SUBJECT: IP REQUEST FOR EXPERT REVIEW OF KRSKO PLANT CHANGES

DRAFT FSAR CHANGES

KRS10 FEEDWATER SYSTEM MODIFICATION

FOR SPLIT FLOW OPERATION

KRSKD FEEDWATER BYPASS SYSTEM CHANGES

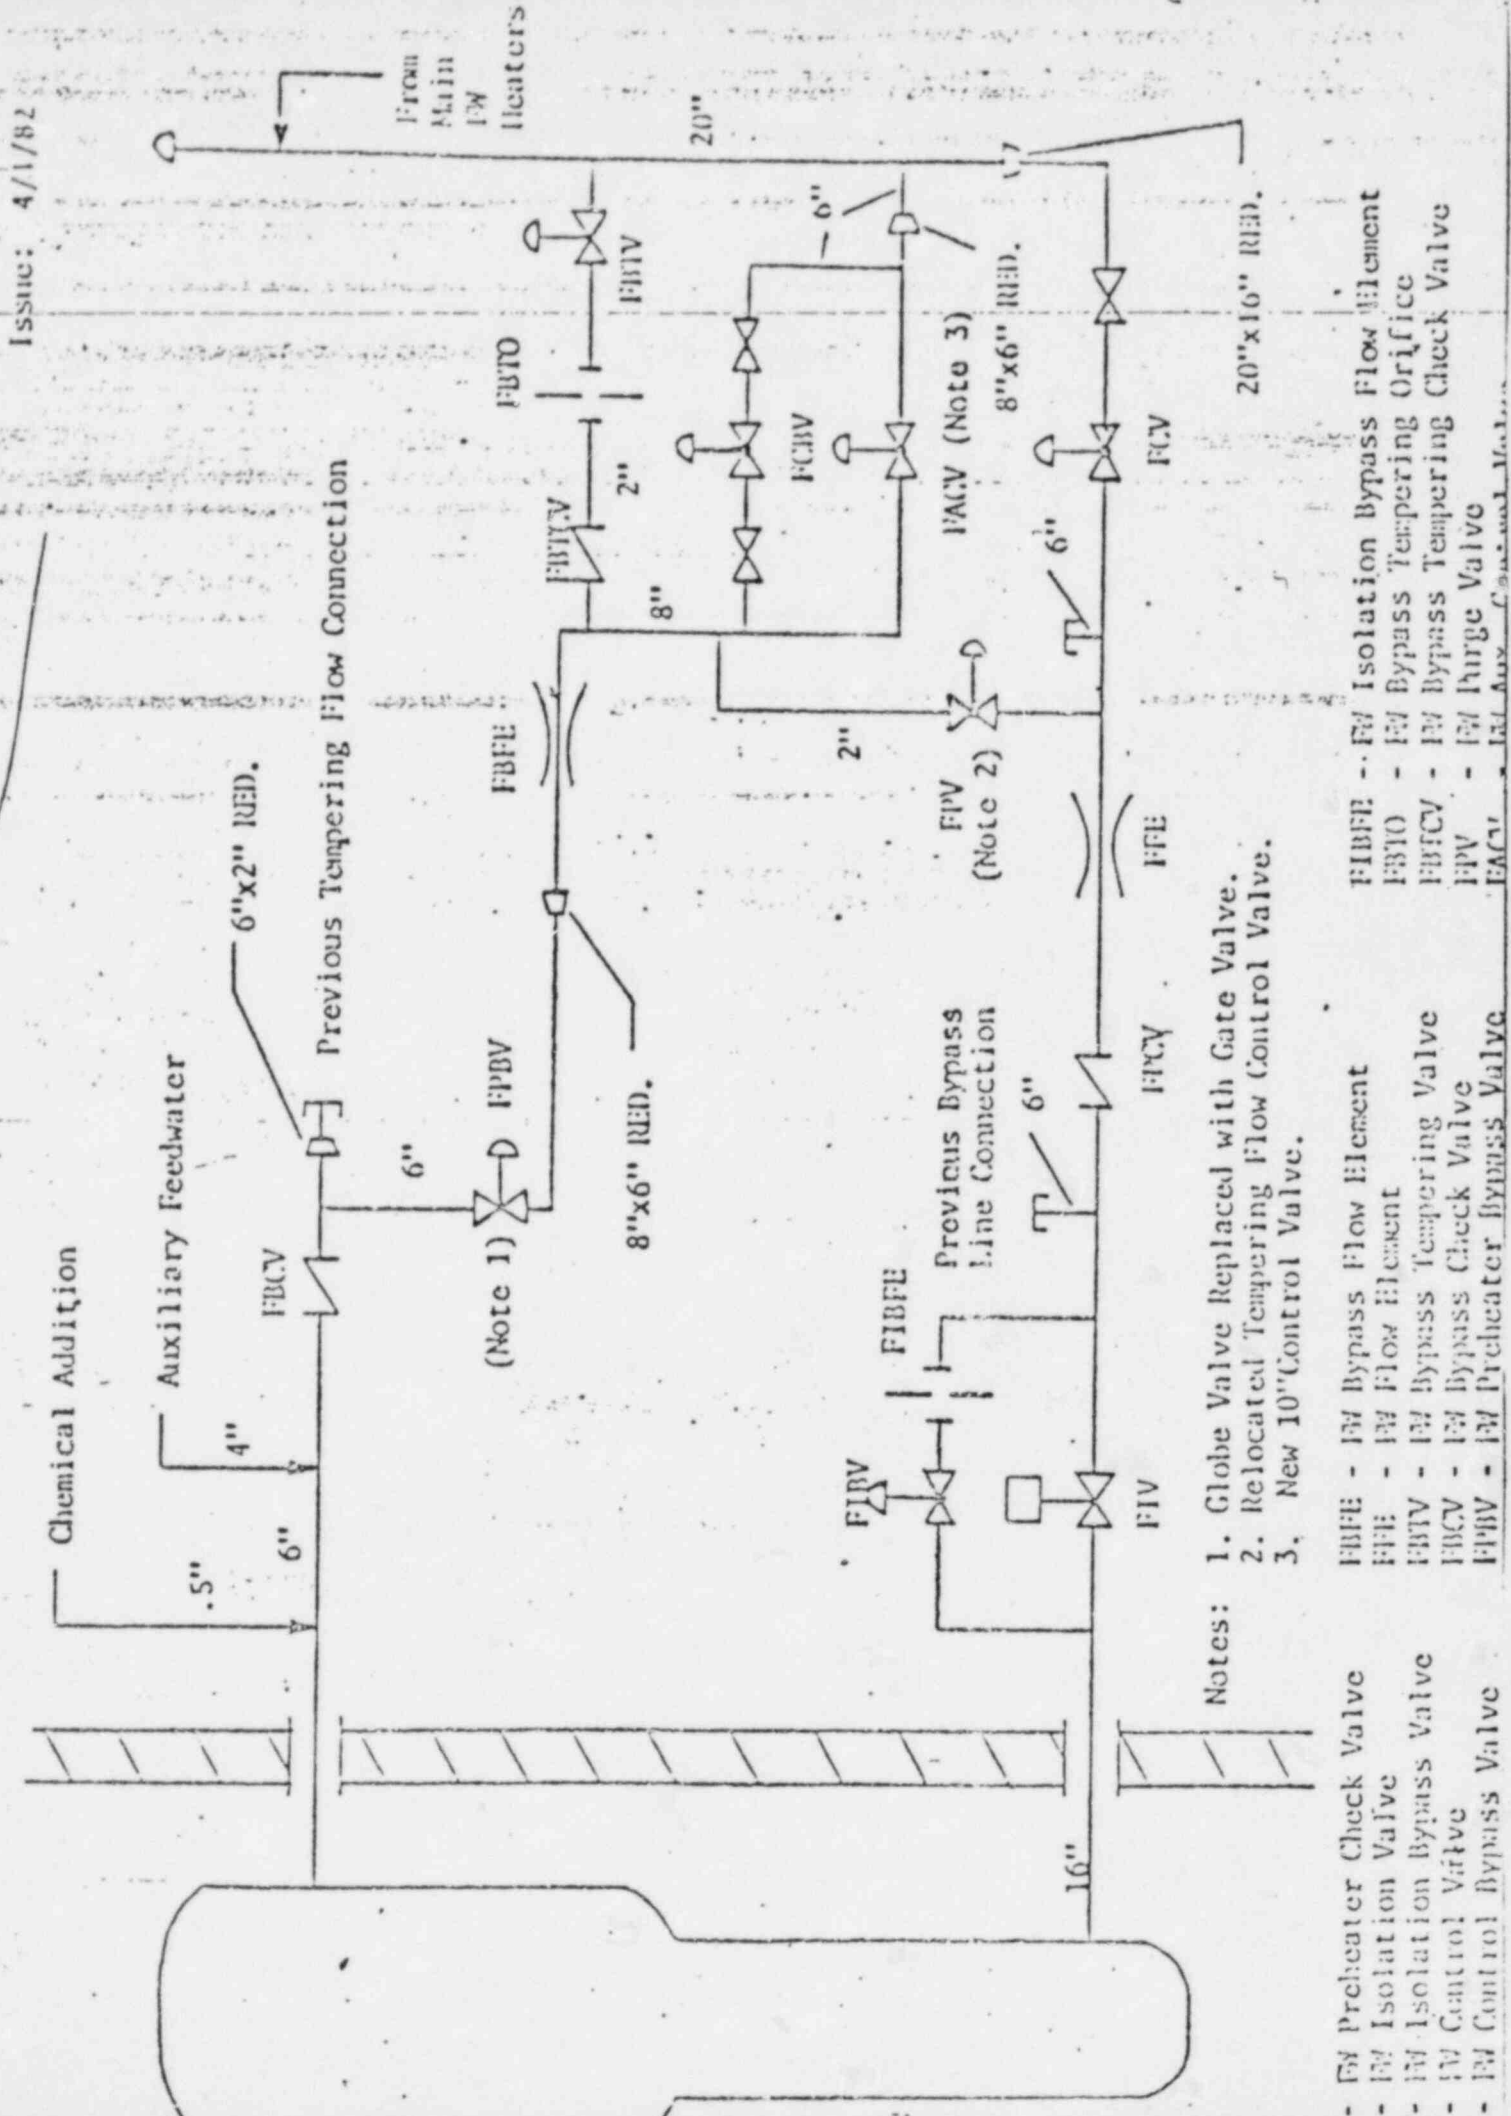
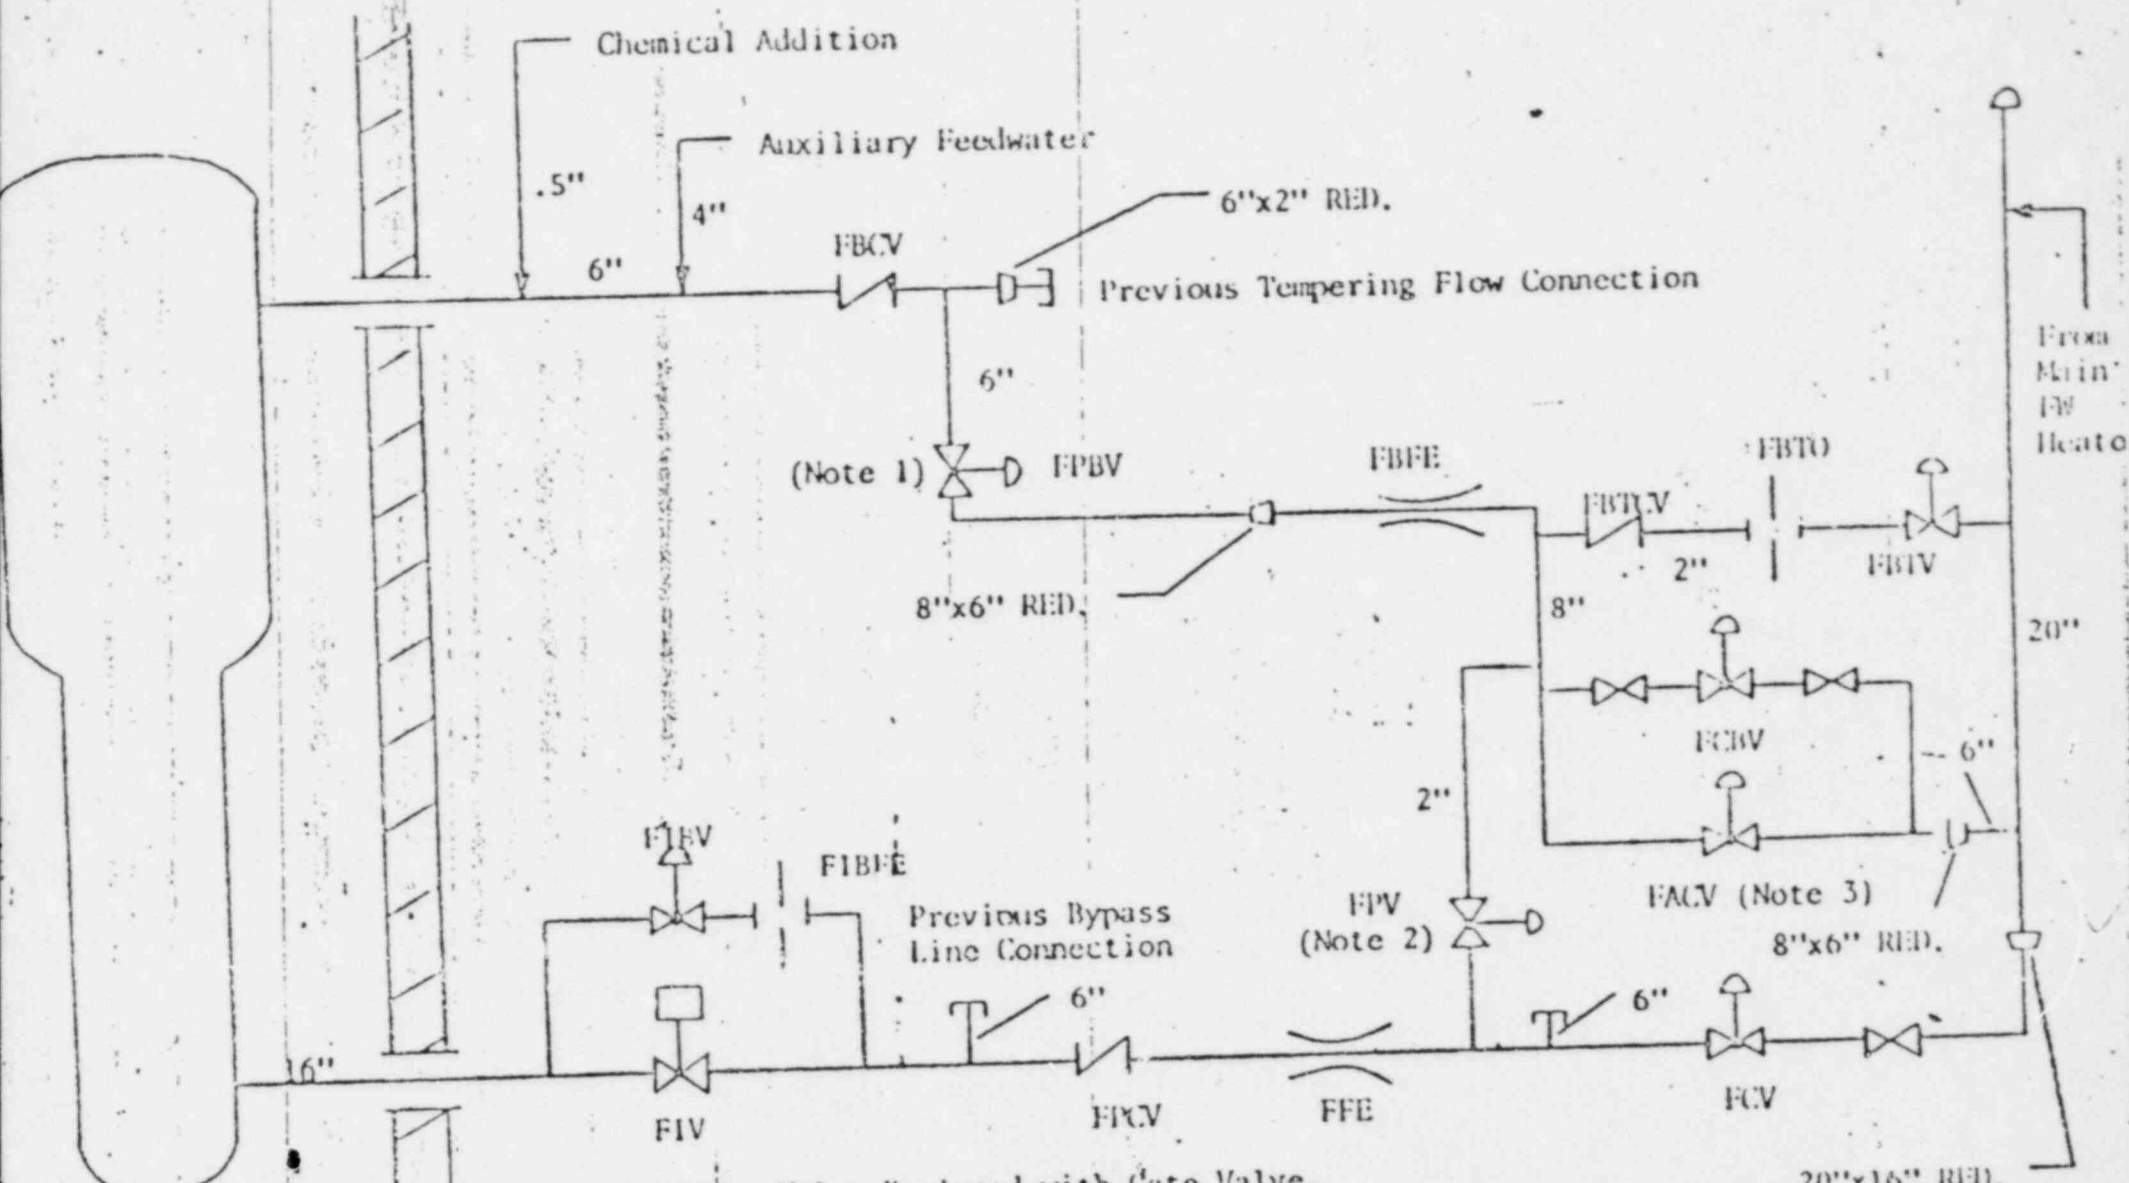
- o THE PREHEATER BYPASS LINE CONNECTION HAS BEEN RELOCATED FROM DOWNSTREAM OF THE FEEDWATER CONTROL VALVE (FCV) TO UPSTREAM OF THIS VALVE.
 - o A NEW 10" FEEDWATER AUXILIARY CONTROL VALVE (FACV) WITH ASSOCIATED 8" PIPING HAS BEEN INSTALLED IN PARALLEL WITH THE EXISTING FEEDWATER CONTROL BYPASS VALVE (FCBV).
 - o THE FEEDWATER PREHEATER BYPASS VALVE (FPBV) HAS BEEN CHANGED FROM A GLOBE TO A GATE VALVE.
-
- o A NEW LINE FOR PURGING HAS BEEN ADDED AROUND THE FCV.
 - o A NEW VENTURI FLOW METER HAS BEEN INSTALLED IN THE BYPASS LINE.
 - o THE PRESENT, PROTECTION GRADE SG WATER LEVEL TRANSDUCER/TRANSMITTER ARE NO LONGER USED FOR CONTROL FUNCTIONS. FOR THE CONTROL FUNCTIONS, A SEPARATE CONTROL GRADE SG WATER LEVEL TRANSDUCER/TRANSMITTER HAS BEEN ADDED.

○ FVC IS NOW CONTROLLED TO LIMIT THE FEEDWATER FLOW INTO THE SG MAIN NOZZLE TO 70%. ABOVE 70% THE FEEDWATER AUXILIARY CONTROL VALVE IS AUTOMATICALLY OPENED TO CONTROL FLOW BETWEEN 70 & 100% POWER.

MAIN CONTROL BOARD CHANGE

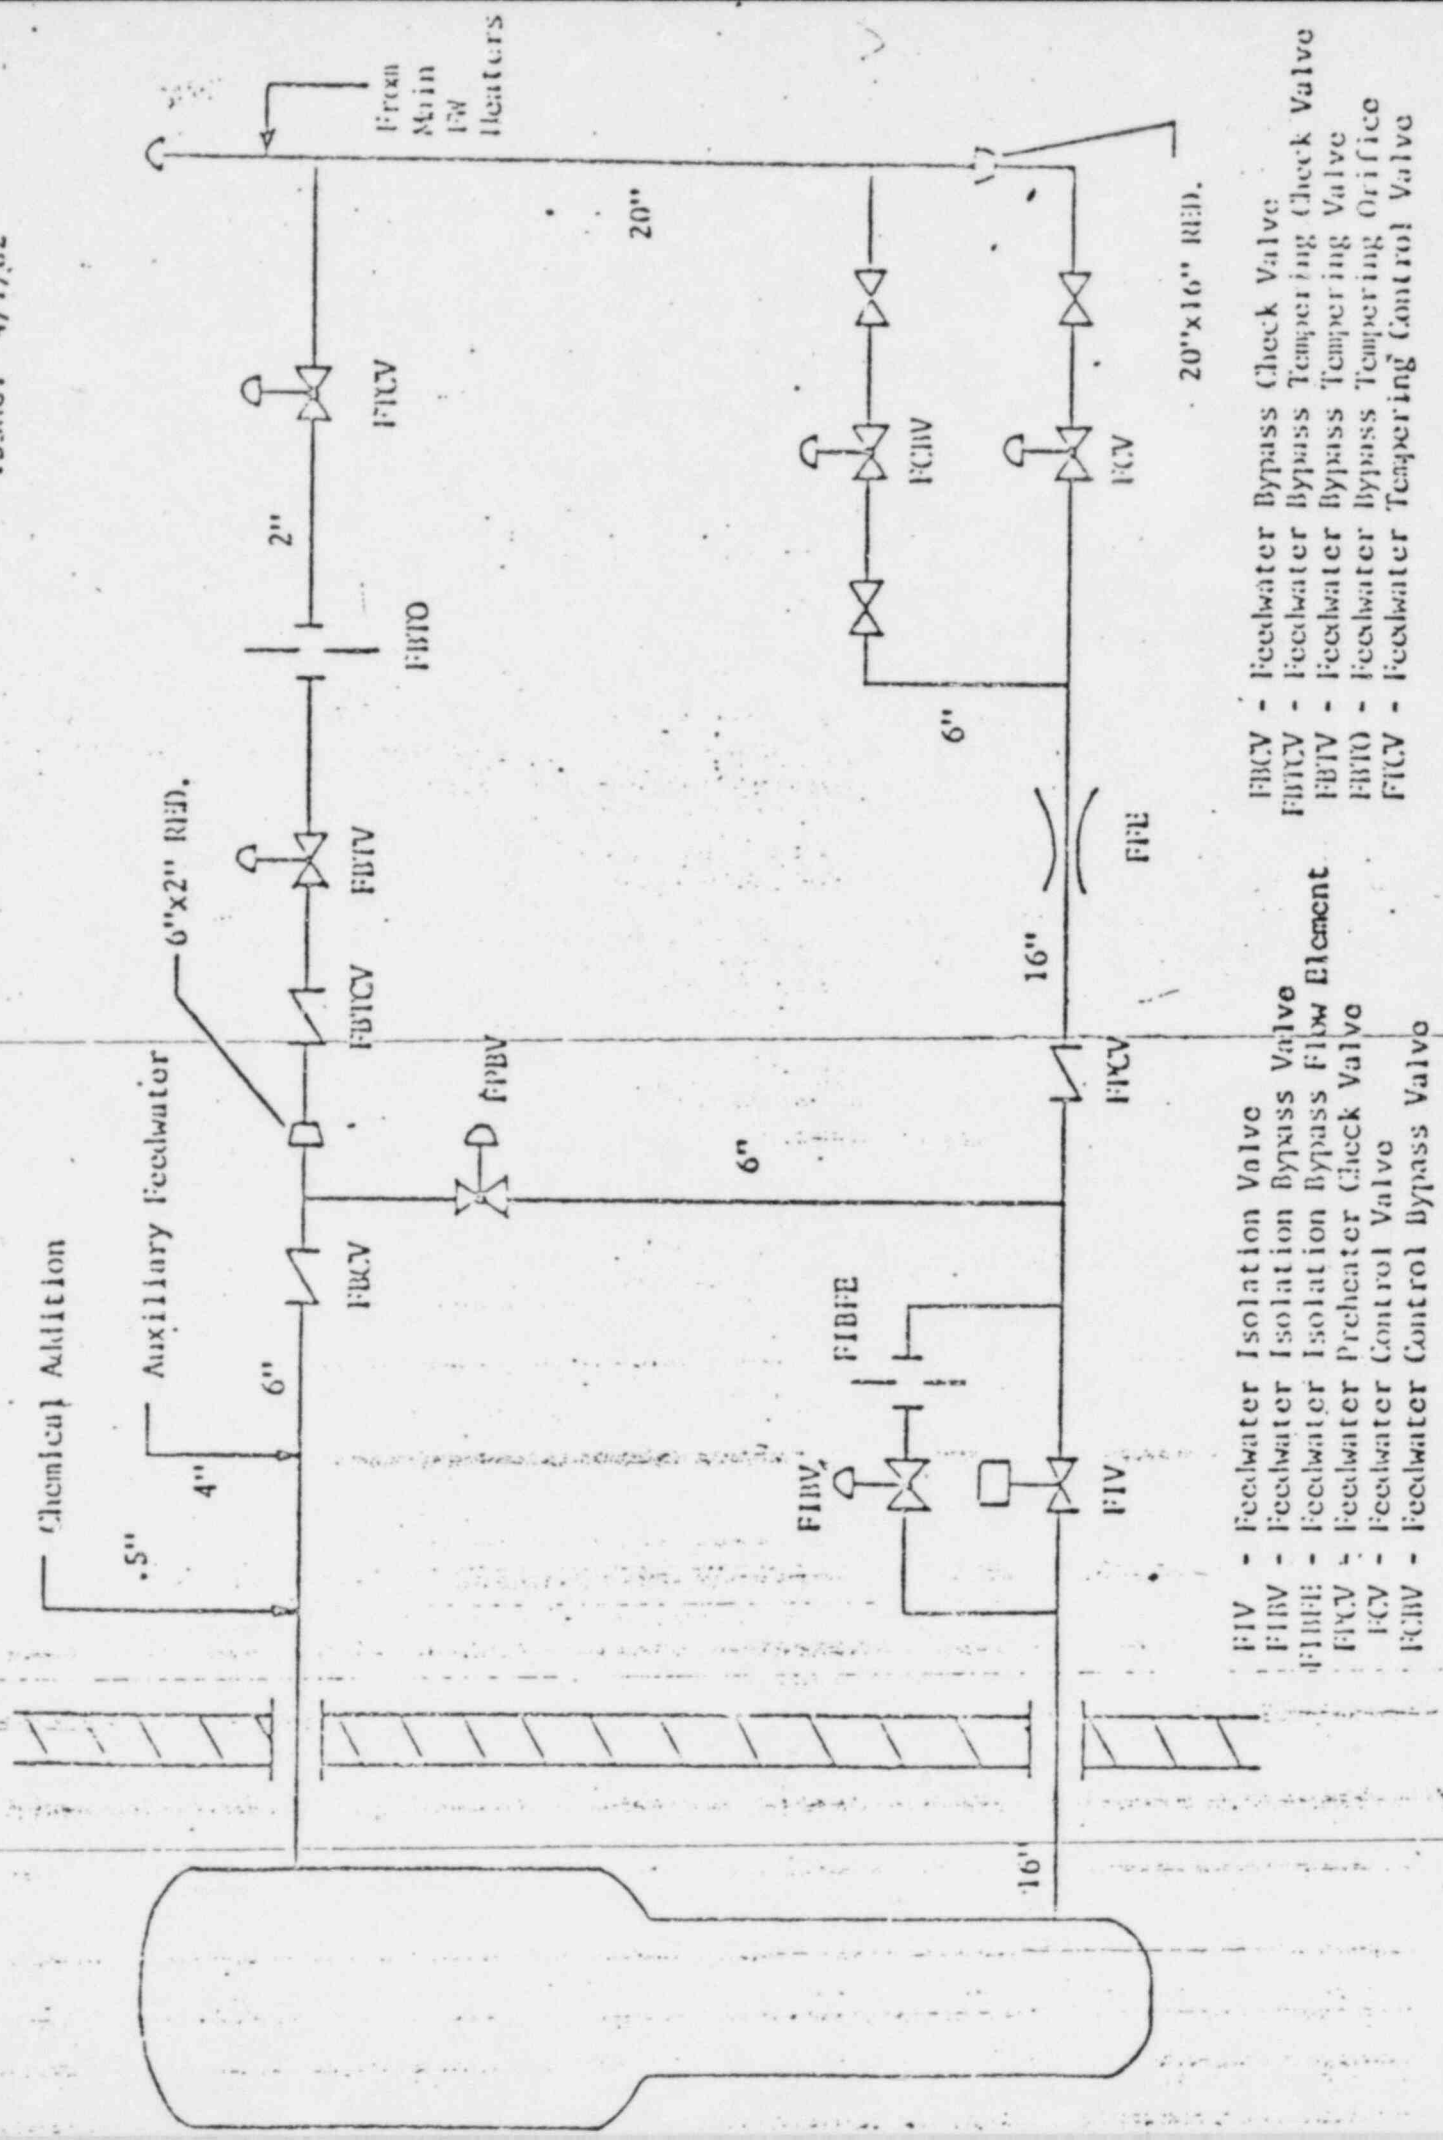
1. CHANGES SCALE ON INDICATORS FI-510 AND FI-520
2. CUT CONTROL BOARD, INSTALL AND WIRE TWO INDICATORS LI-551 AND LI-552
3. REMOVE SWITCH MODULES FS-510Z (ITEM 149) AND FS-520Z (ITEM 150), ENLARGE TWO CUTOUT, INSTALL ADAPTER PLATES AND INSTALL AUTO/MANUAL STATIONS FK-551B AND FK-552B
4. PROVIDE BLANK LIGHT BOX LENS FOR ANNUNCIATOR LIGHT BOX ALBOS AND FOR FEEDWATER VALVES STATUS LIGHT BOX (CONTROL BOARD SECTION B)

FEEDWATER

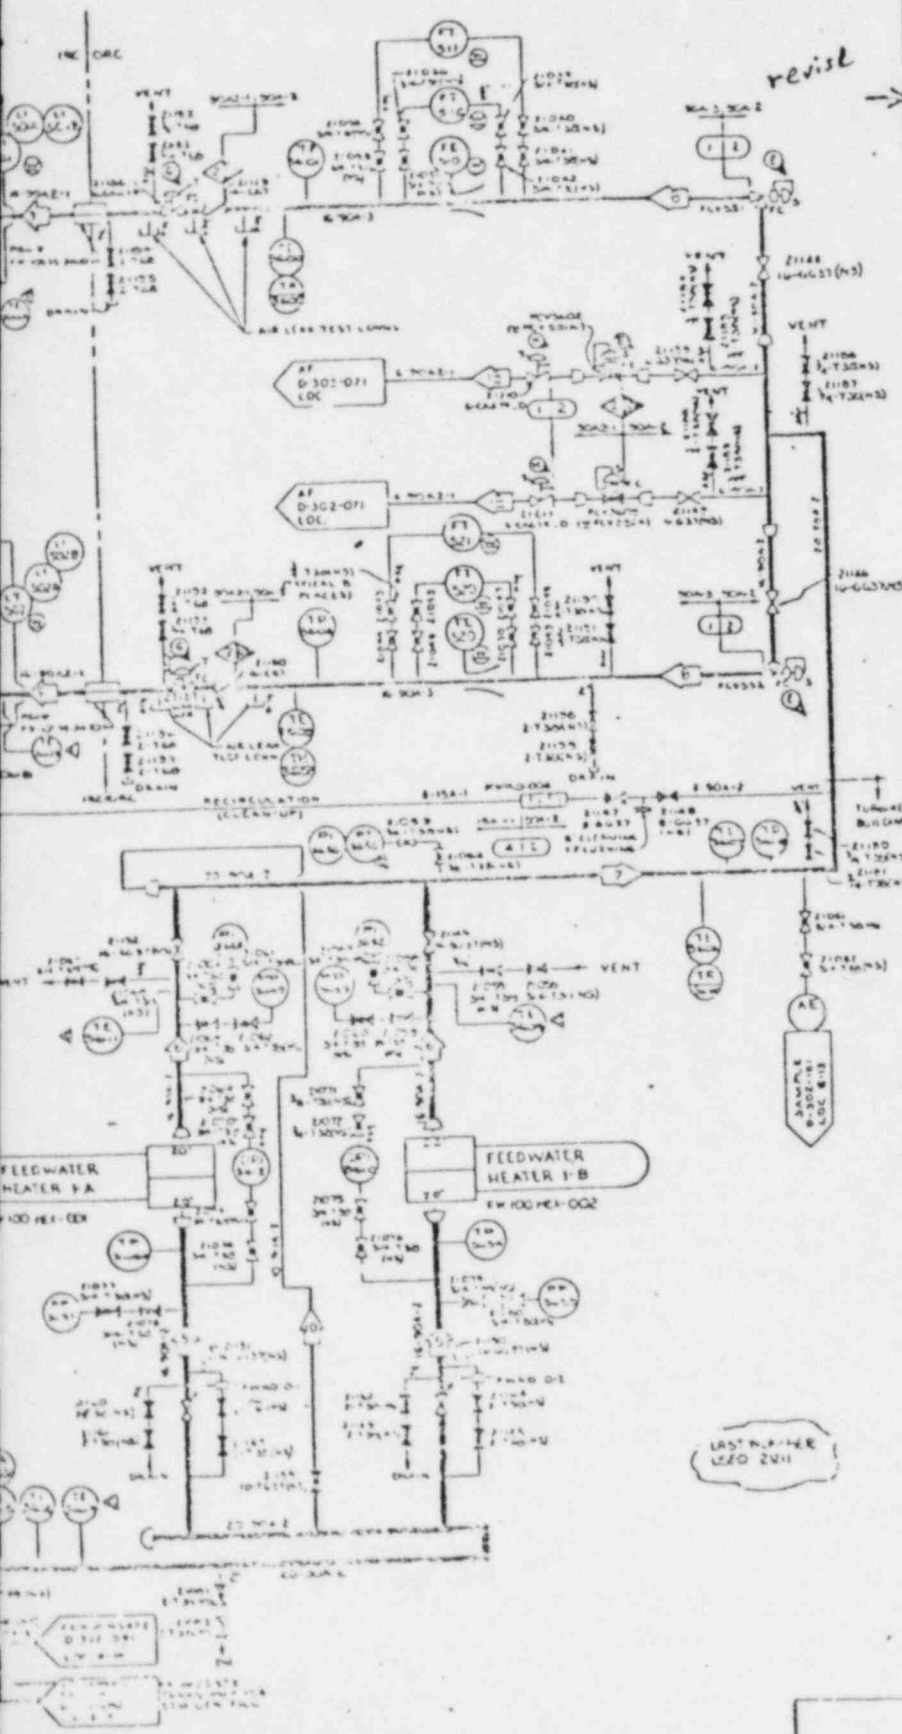
Add FACV and lines
